Access Compliance Report

Public Rights-of-Way

(Pedestrian Signals)

Intersection ID: N/A	Main Street:	Cross Street: N/A	Location: N/A
ADA ID: FBA1386185DE	Signal Type: One Push Button-Non APS	Overall Compliance: No	Severity Score: BTN 1: N/A BTN 2: N/A No BTN: N/A
Codes/Mitigation Info/Possible Solution		Field Measurements/Component Compliance

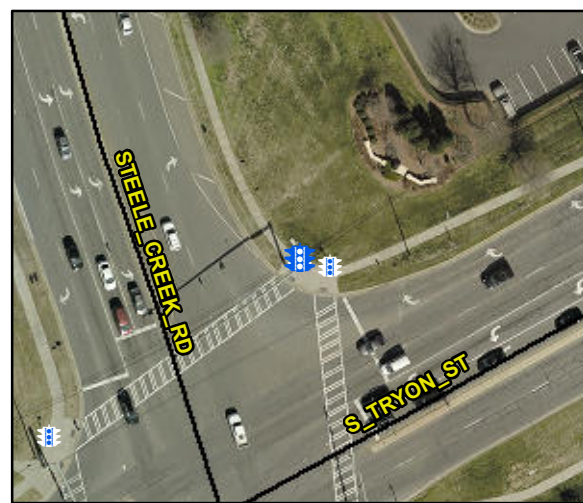
Surveyor Notes: TEXT HT 1/2

PROW/ADA: R410.6, TMUTCD 4e.08, R404.2

Yes	B 1 Clear Xing Direction?	ClearlyMarked	N/A	B 2 Clear Xing Direction?	N/A
	B 1 Crossing Direction	To SW		B 2 Crossing Direction	N/A
Yes	B 1 DistanceTo XWalk (in)	0.0	N/A	B 2 DistanceTo XWalk (in)	N/A
No	B 1 DistanceTo Curb (in)	160.0	N/A	B 2 DistanceTo Curb (in)	N/A
Yes	B 1 Diameter (in)	2.0	N/A	B 2 Diameter (in)	N/A

Possible Solutions: Replace Signal Push Button With APS Button on New Post. Remove & Replace Sign.
